Serial No. 01-018
NLOS/ETS R
Docket No. 50-338
License No. NPF-4

VIRGINIA ELECTRIC AND POWER COMPANY
NORTH ANNA POWER STATION UNIT 1
PROPOSED OPERATING LICENSE AND TECHNICAL SPECIFICATIONS CHANGES
DELETION OF OBSOLETE LICENSE CONDITIONS

MARK-UP OF OPERATING LICENSES AND TECHNICAL SPECIFICATIONS PAGES

FIGURE 1
MAXIMUM ALLOWABLE PRIMARY CONTAINMENT AIR PARTIAL PRESSURE VS SERVICE WATER TEMPERATURE AND RWST WATER TEMPERATURE
NORTH ANNA POWER STATION UNIT 1

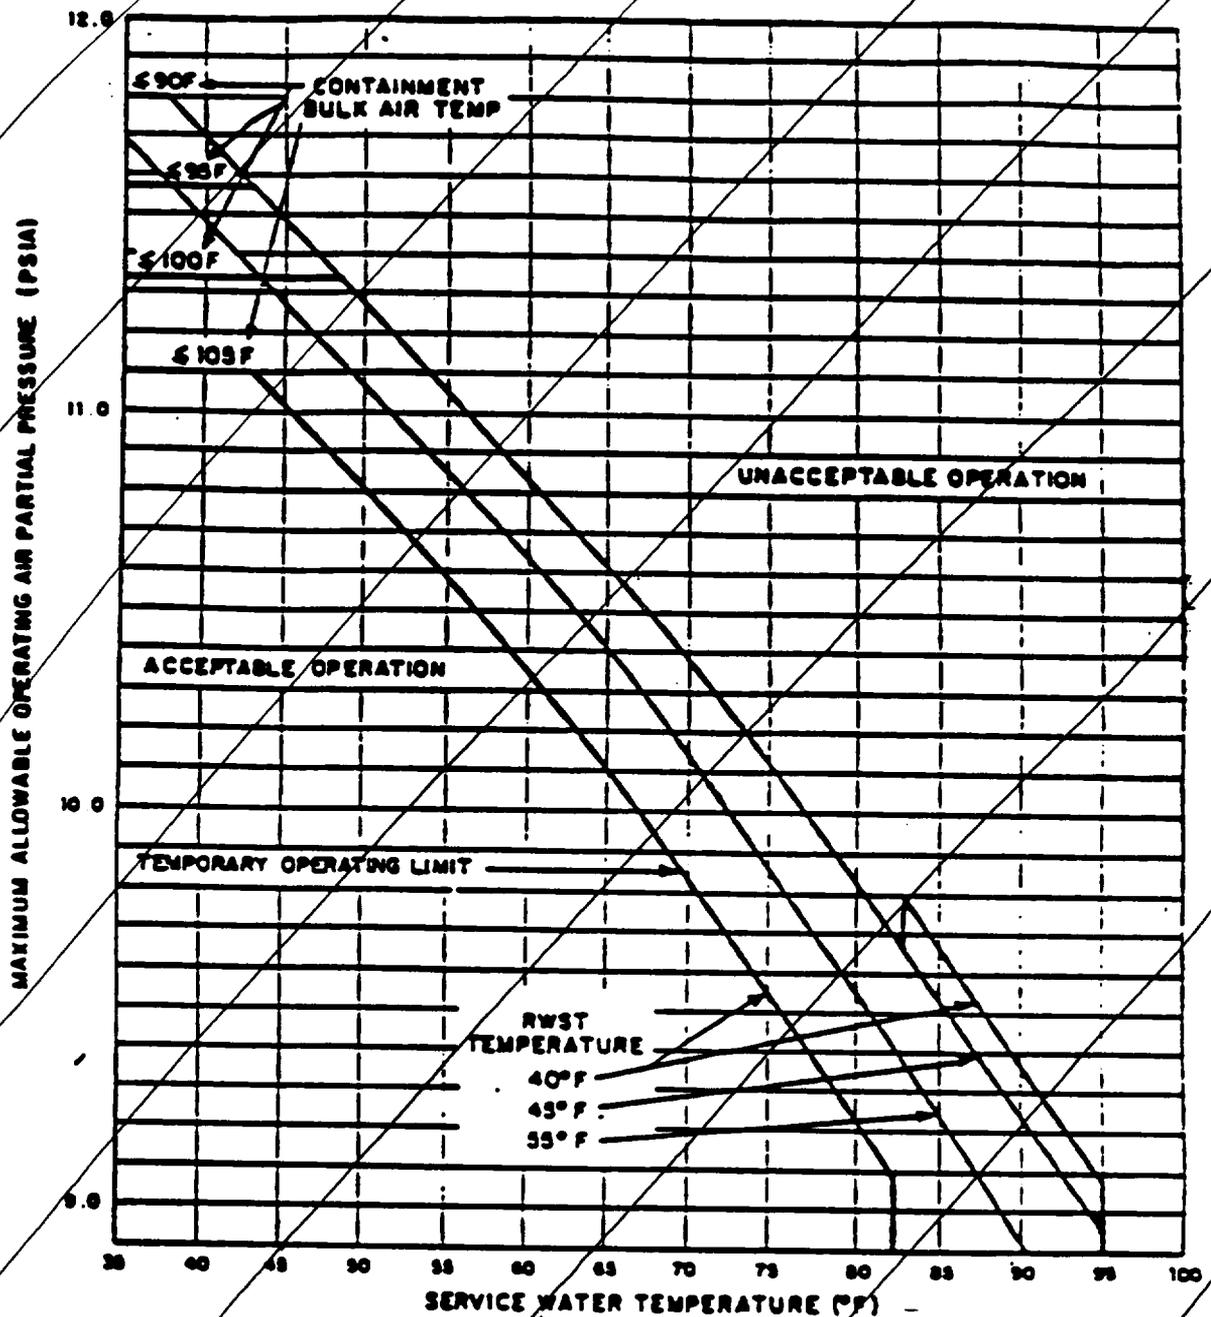
FOL Attachment 3 - Attachment 3 was added to the North Anna Unit 1 FOL via License Amendment No. 3 and contained Figure 1 which provided limitations on containment air partial pressure. These limitations were related to evaluations and modifications needed to address the Net Positive Suction Head in the containment sumps. License Amendment No, 13 dated August 3, 1979 removed the license condition that referenced Figure 1 (Attachment 3). The SER for License Amendment No. 13 stated that an IE inspection had verified that all necessary actions had been completed and that the license condition containing the reference to Figure 1 was complete. This inspection was documented in IE Inspection Report 50-338/78-17. Therefore, Attachment 3 is deleted by this proposed change to the North Anna Unit 1 FOL.

- FOL Appendix C is deleted since the content has been relocated into the “Additional Conditions” of FOL Section 2.C(3).
- Attachment 3 (Figure 1) is deleted since it is no longer applicable.

Figure 2.1-1a REACTOR CORE SAFETY LIMITS FOR THREE LOOP OPERATION FOR THE PERIOD OF OPERATION UNTIL STEAM GENERATOR REPLACEMENT

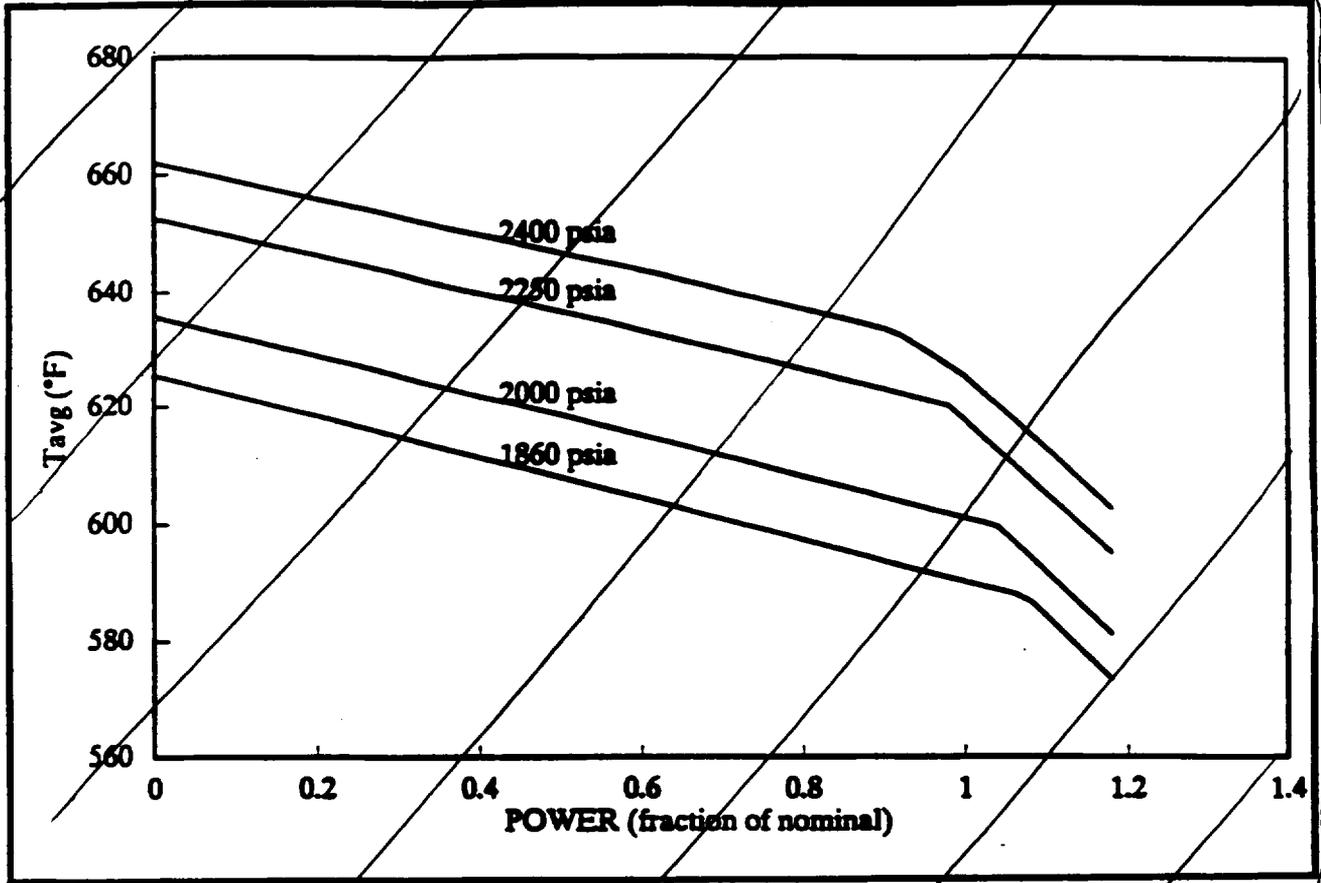
2. Appendix B, Environmental Protection Plan
- Attachment 1 to the FOL is deleted since all “construction related items” have been completed.
- The asterisk and the footnote in TS 2.1.1 regarding TS Figure 2.1-1a are deleted since they are no longer applicable following replacement of the Unit 1 steam generators.

- The alternate Reactor Core Safety Limits figure, TS Figure 2.1-1a, is deleted since it is no longer applicable following replacement of the Unit 1 steam generators.

§
For the period of operation until steam generator replacement, the combination of THERMAL POWER, pressurizer pressure, and the highest operating loop coolant temperature (T_{avg}) shall not exceed the limits shown in Figure 2.1-1a. 4
